Concerns, recommendations and questions related to Locust Hill project 7-SB-25-C

8-6-25 Submitted on behalf of residents on Locust Hill Lane and Chapman Hwy

Map 7: Hillside and Ridgetop Protection Plan

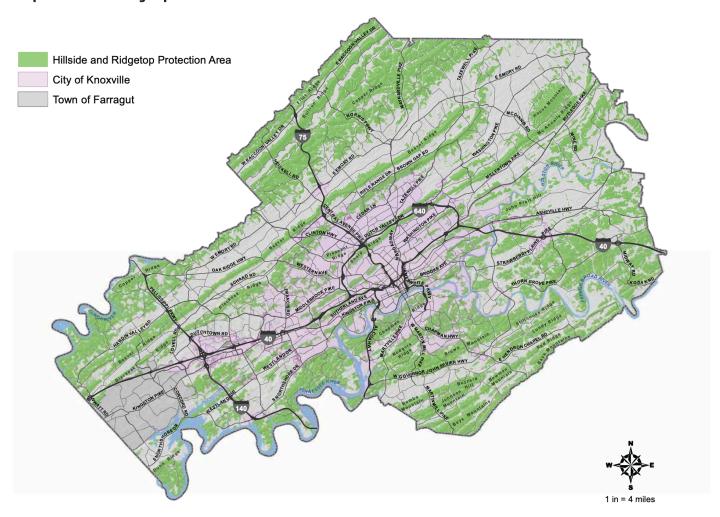
5. The City of Knoxville passed Hillside and Ridgetop Protection Plan regulations in 2012. This proposed development appears to fall in the Hillside and Ridgetop Protection Area (see Map 7 of handout). According the the city regulations, the protection area has restrictions on use and the amount of land that can be disturbed, depending on slope. This development proposal appears to be using an average slope of all nine initial lots proposed. We believe it is more appropriate to calculate the slope on each lot separately. For example, the slope of existing lots #4 & #5 is 28%. If individual lot slopes are used, according to the Hillside regulations, the maximum land disturbance recommended is 20% (see Table 3 of handout).

Is this proposal in compliance with Hillside and Ridgetop Protection Plan? Were any recommendations of the Chapman Highway Corridor Study prepared by the Knoxville Knox County Metropolitan Planning Commission in 2006 considered?
